Lake Merritt Station Area Plan

Final Environmental Impact Report

July 2014

Prepared for the **City of Oakland** by

Figure 2.4-1
General Plan and Estuary
Policy Plan (Amendments)

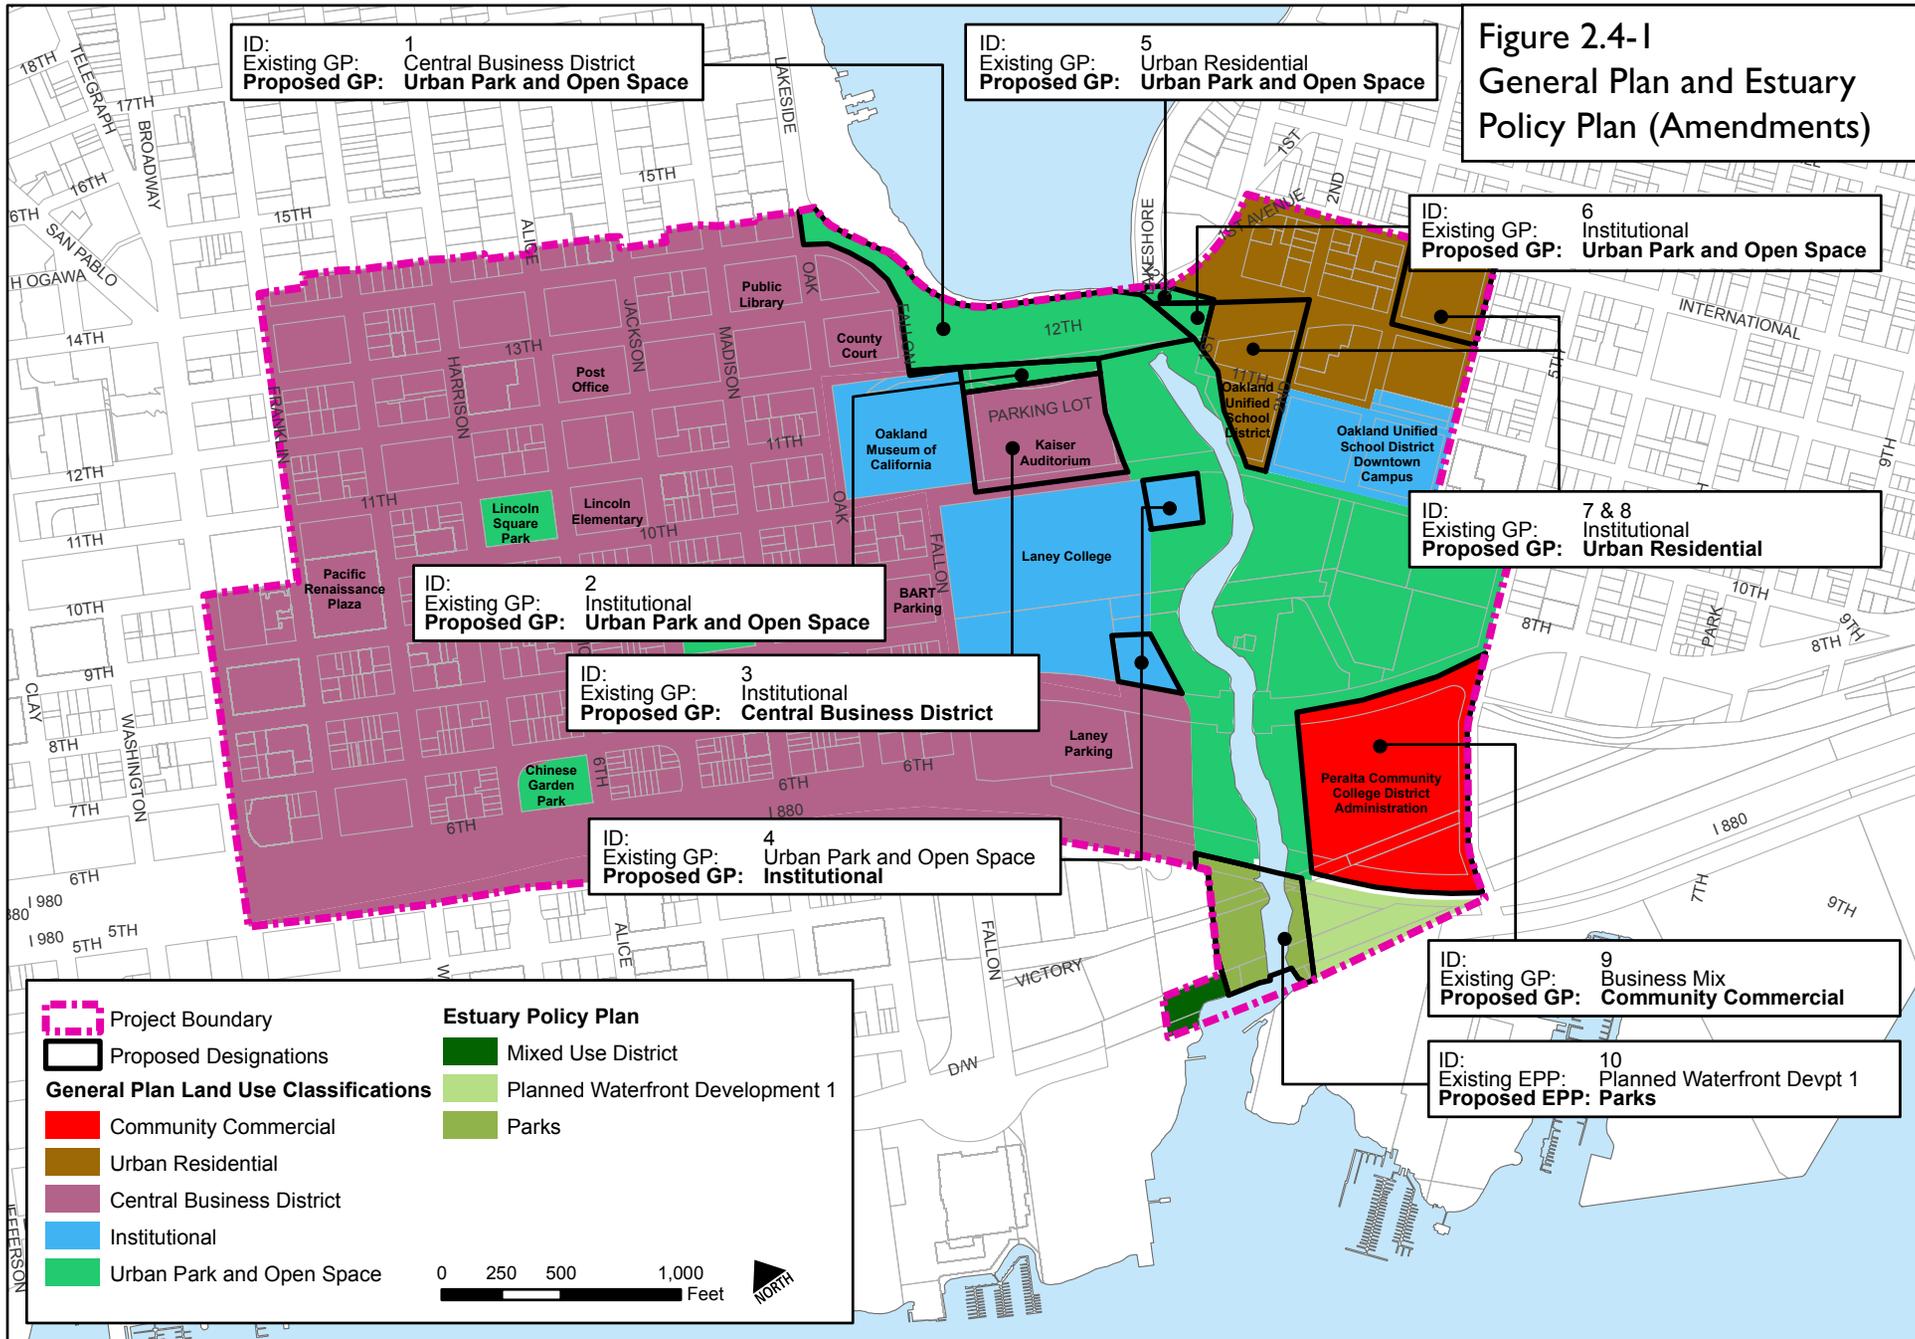
- Figure 2.4-1: General Plan and Estuary Policy Plan Amendments is revised to clean up formatting by removing the opportunity sites from the map.
- Figure 2.4-2: Existing Zoning Districts is revised to clean up formatting by removing Chinese street names and opportunity sites.

**Figure 2.4-2
Existing Zoning Districts**

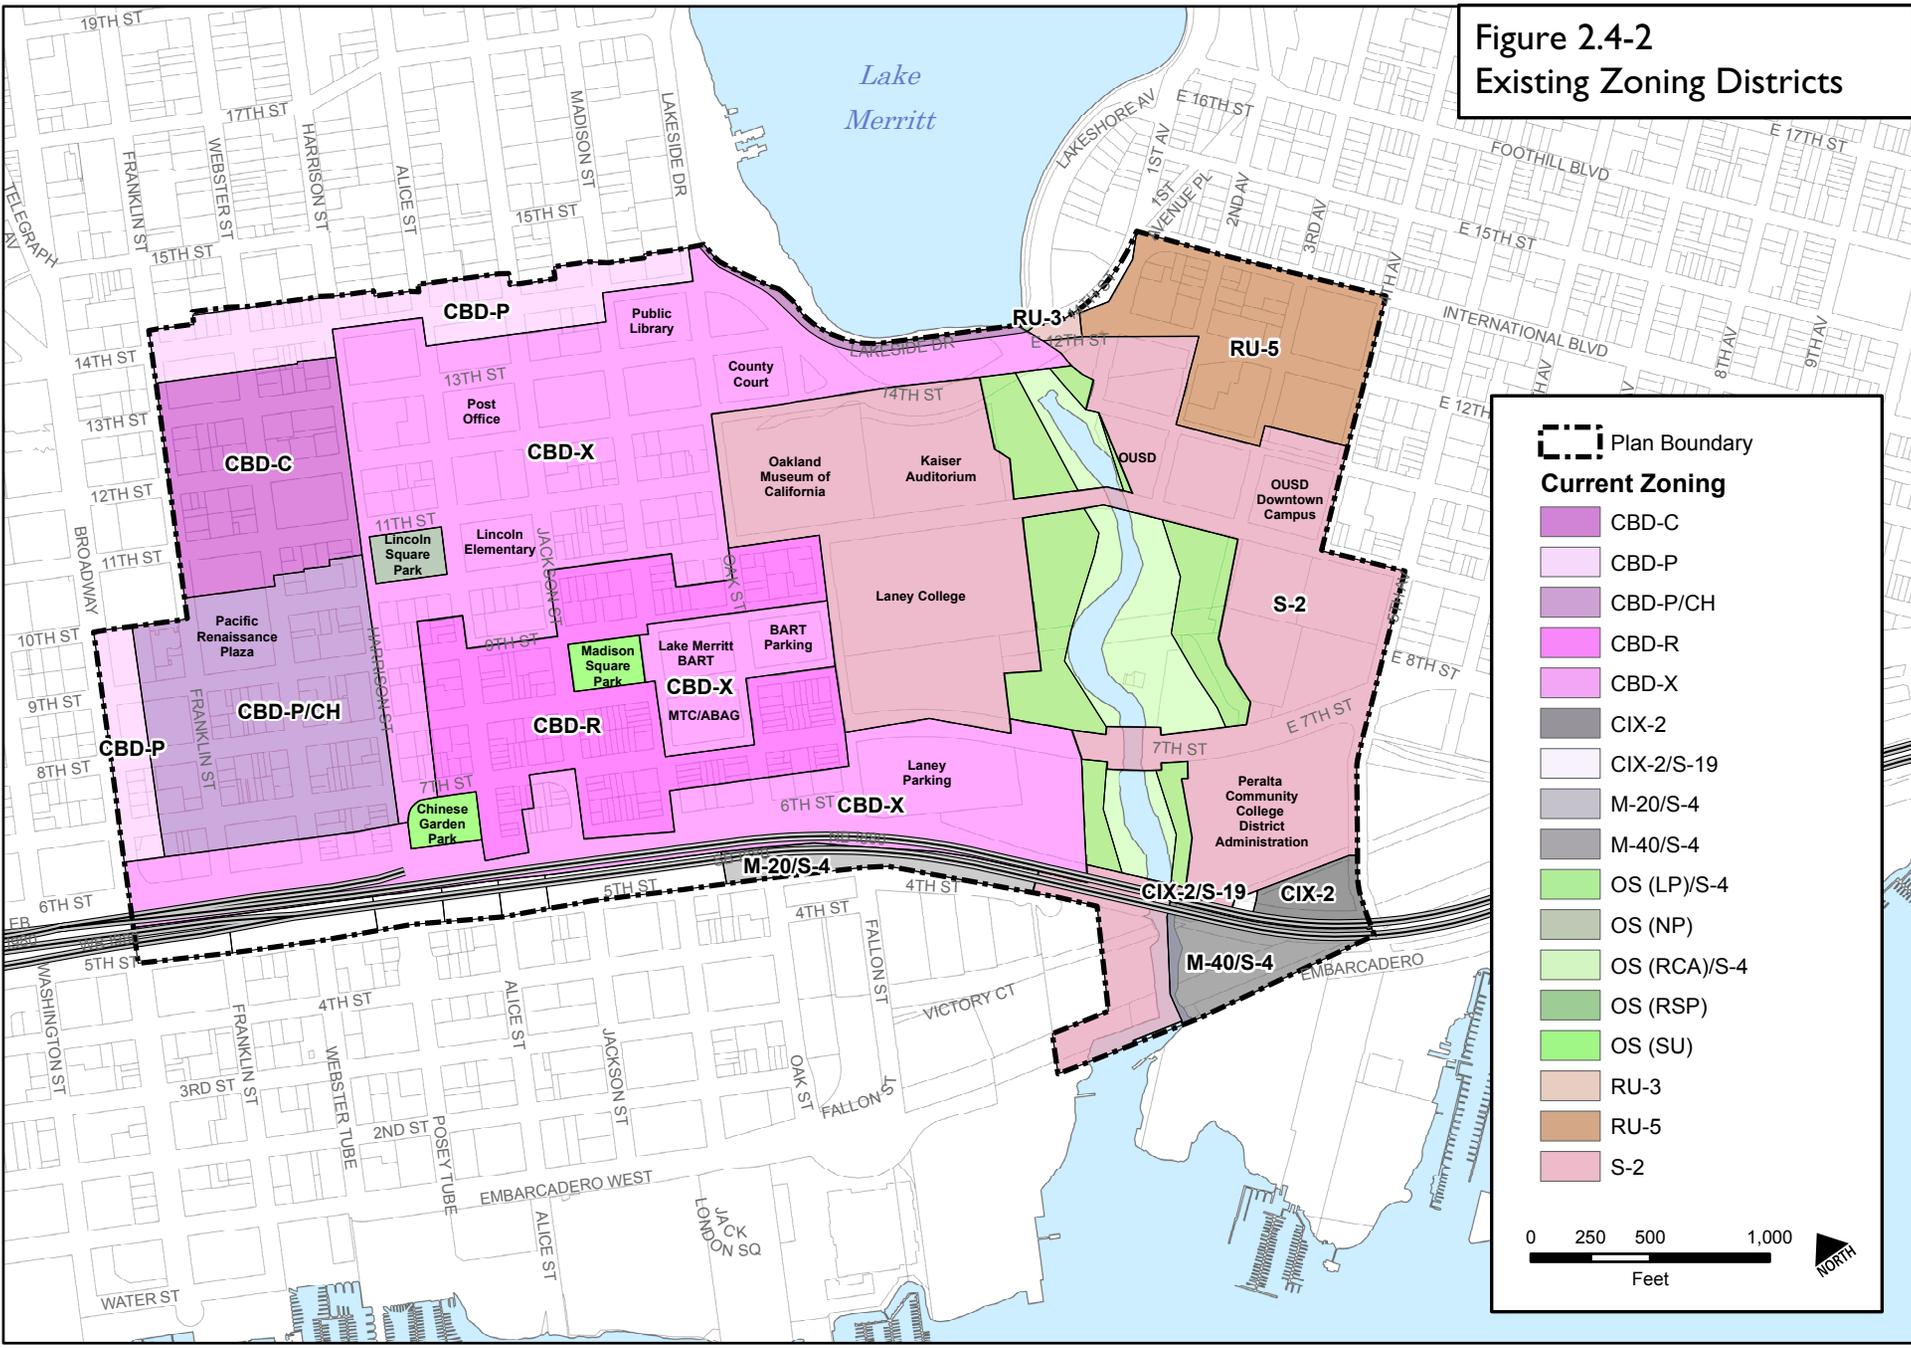
Figure 2.4-2: Existing Zoning Districts is revised to remove Chinese street names and opportunity sites.

**Figure 2.4-3
Proposed Zoning Districts**

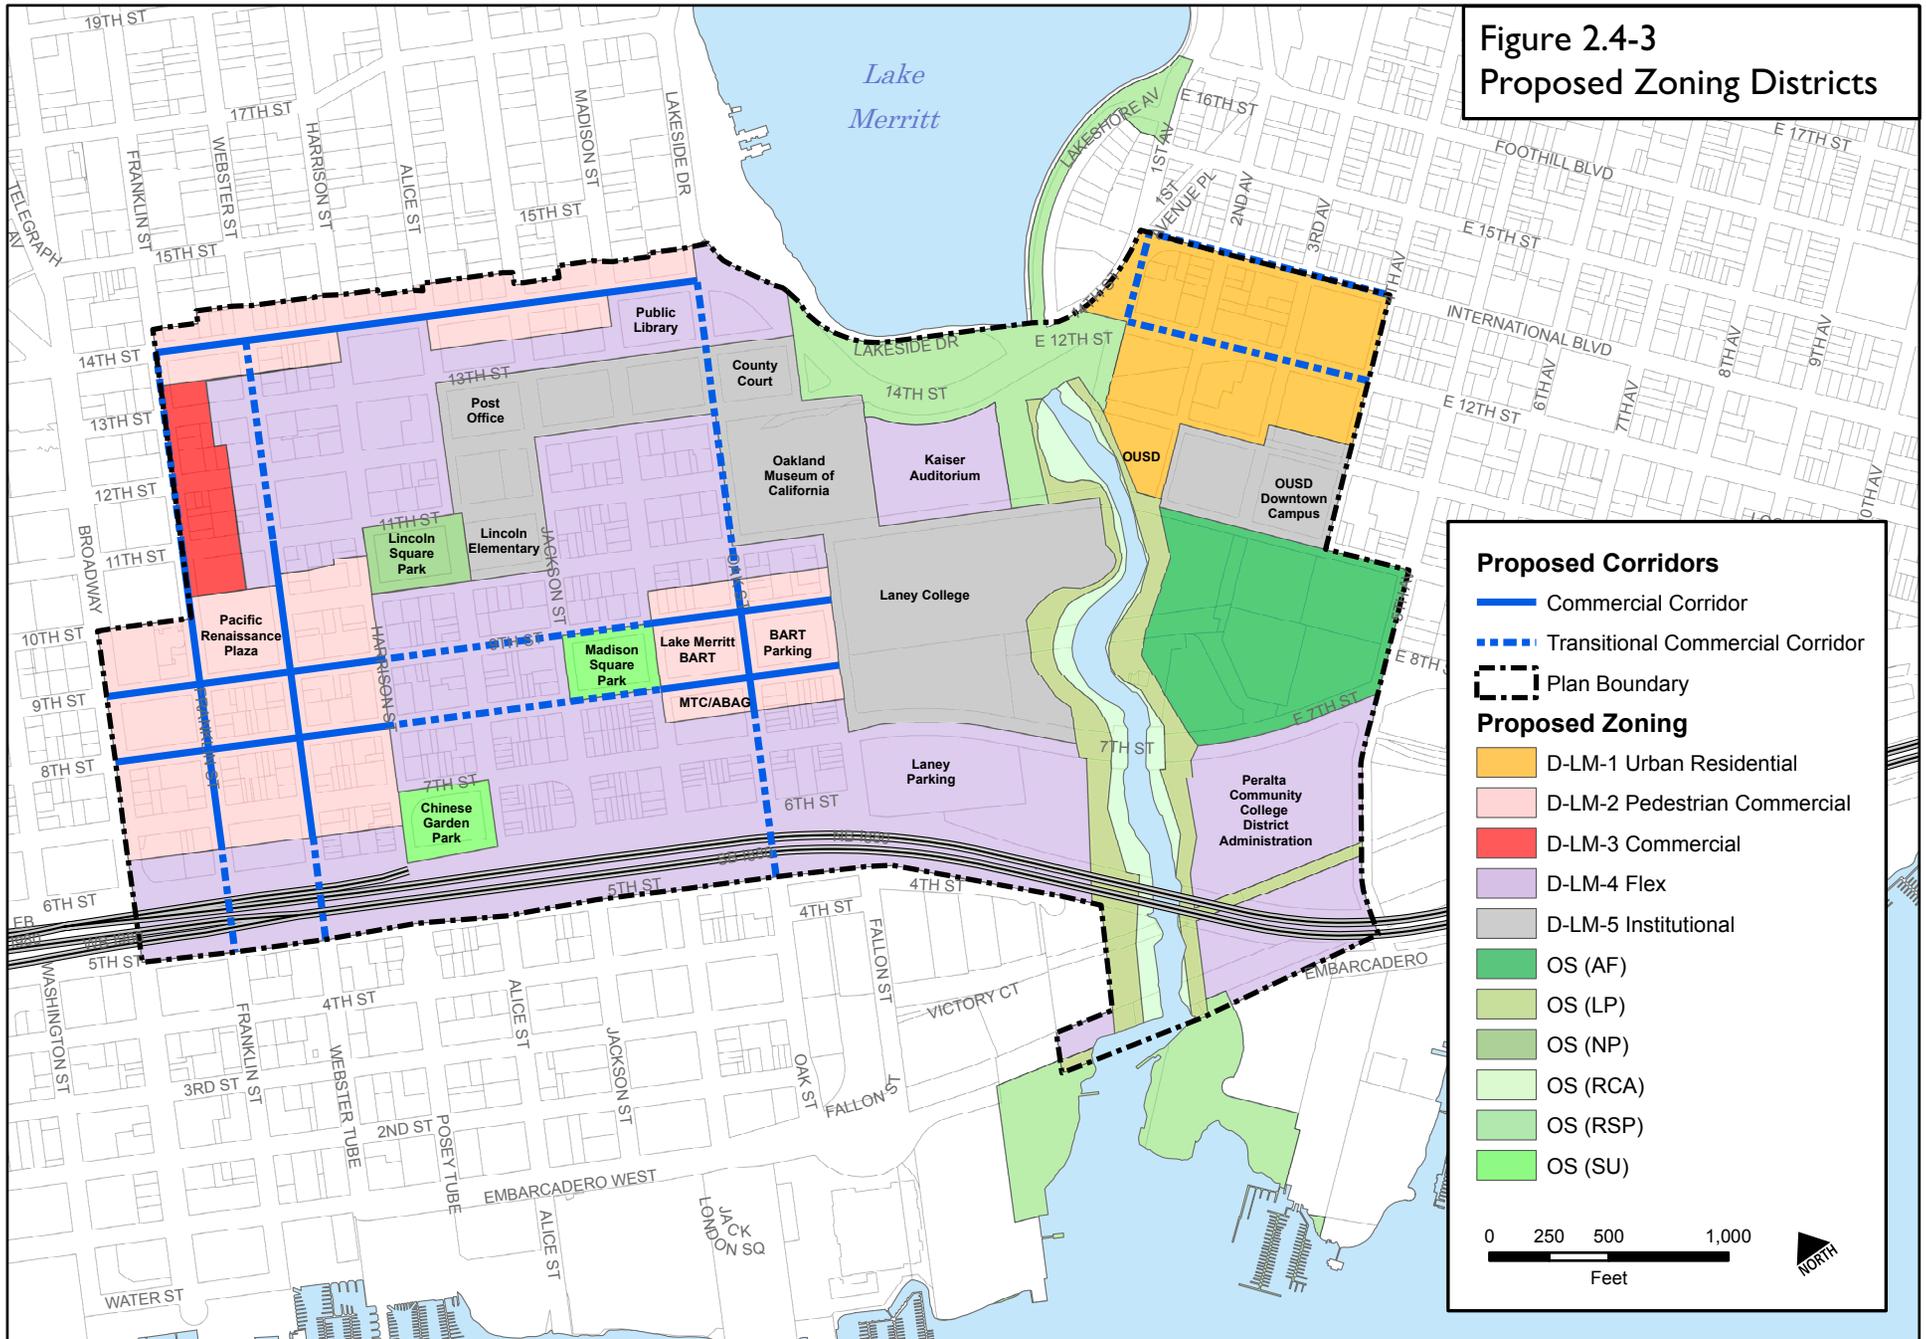
- Figure 2.4-3: Proposed Zoning Districts is revised to clean up formatting by extending the Open Space district to the existing open space on the public right of way between Lincoln Park and Lincoln Elementary School; extending the Pedestrian Commercial district from the edge of the BART blocks to the Madison Street centerline; and correct the label/symbology match for the Commercial Corridor and Transitional Commercial Corridor

**Figure 2.4-4
Existing Height Limit**

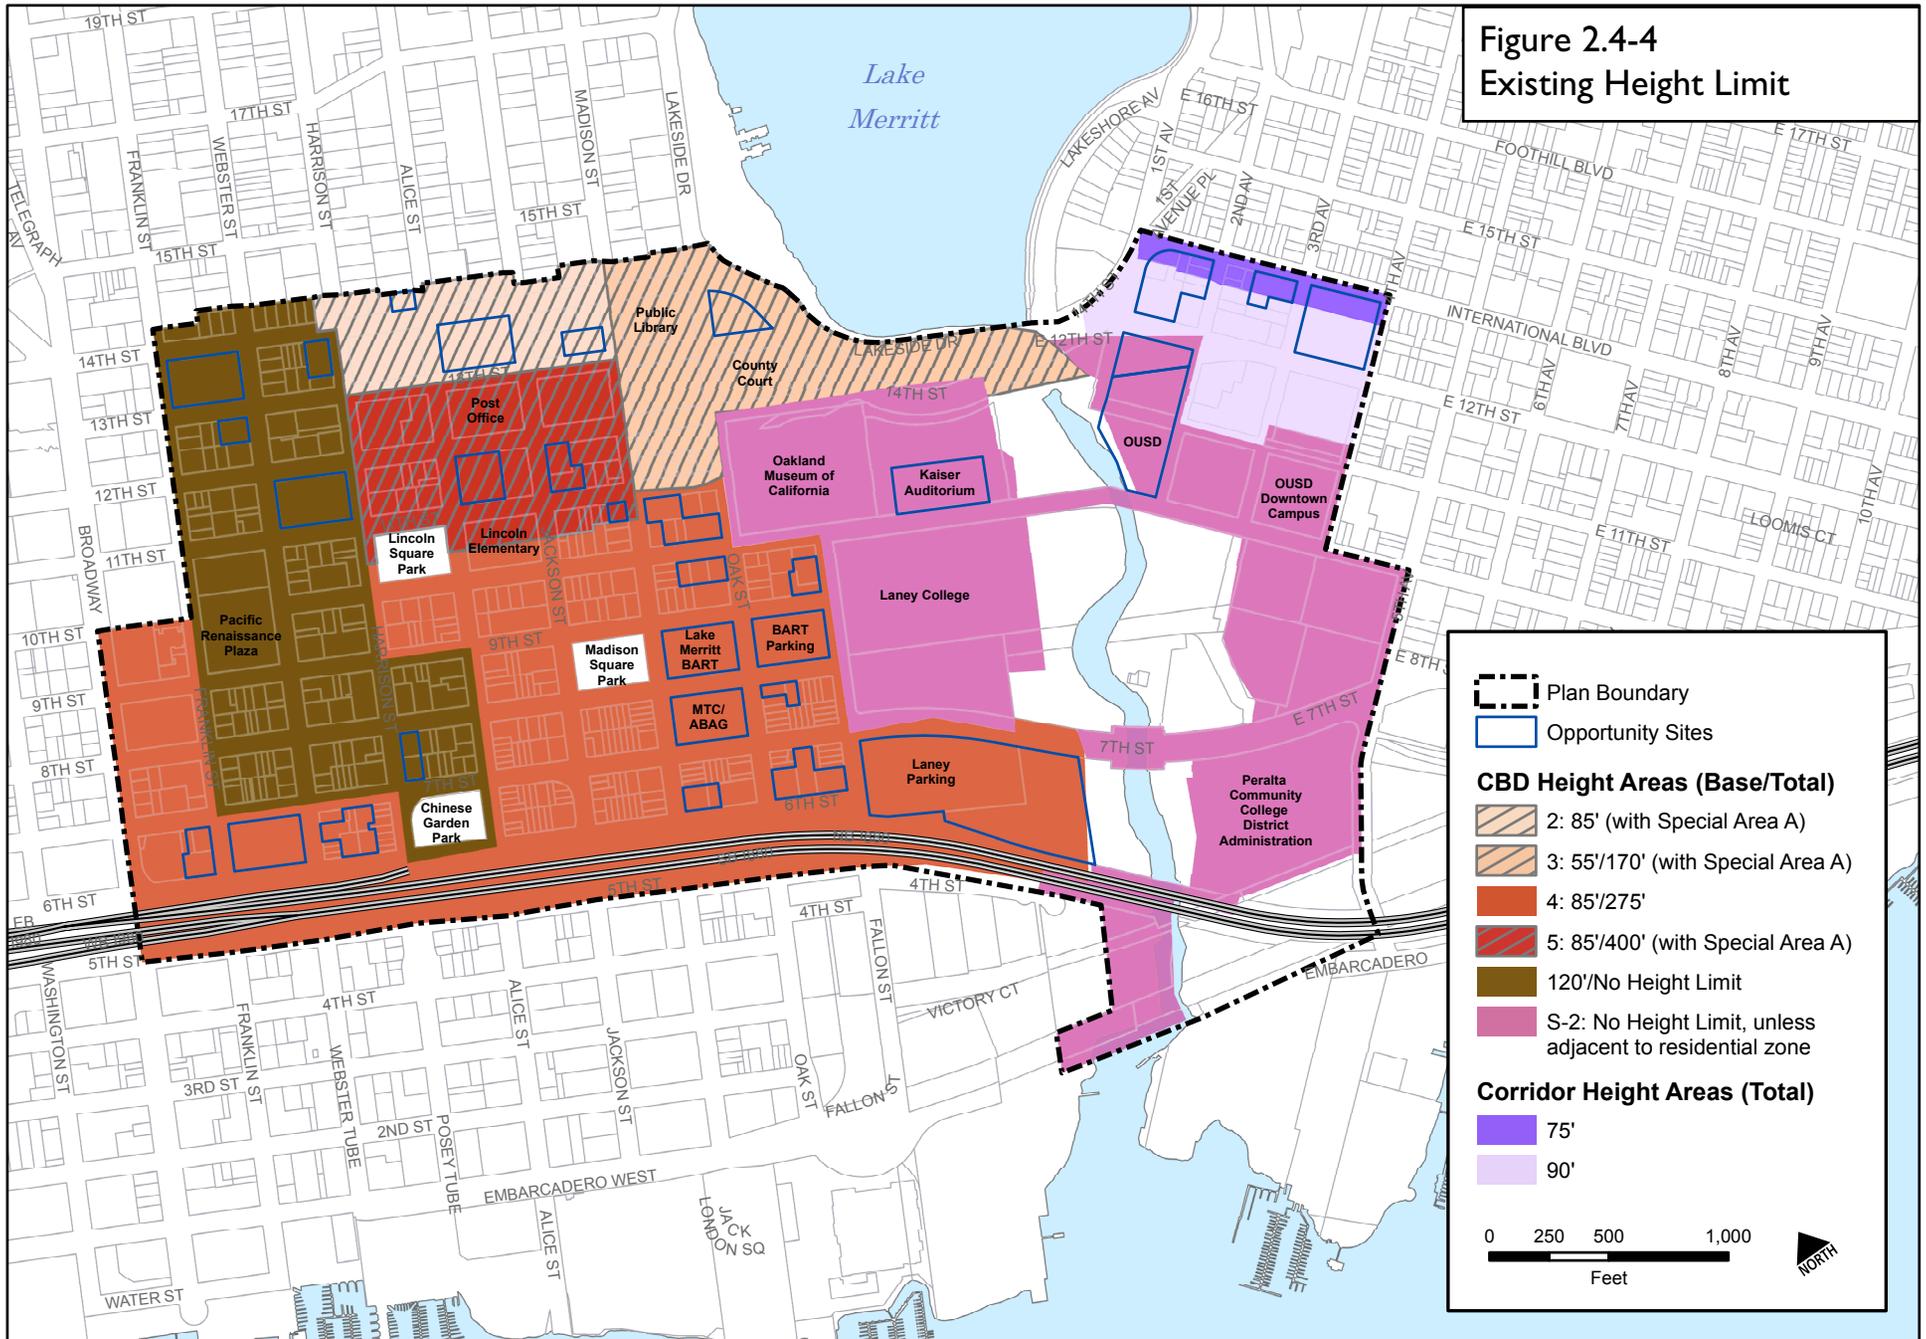
Figure 2.4-4: Existing Height Limits is revised to clarify opportunity sites.
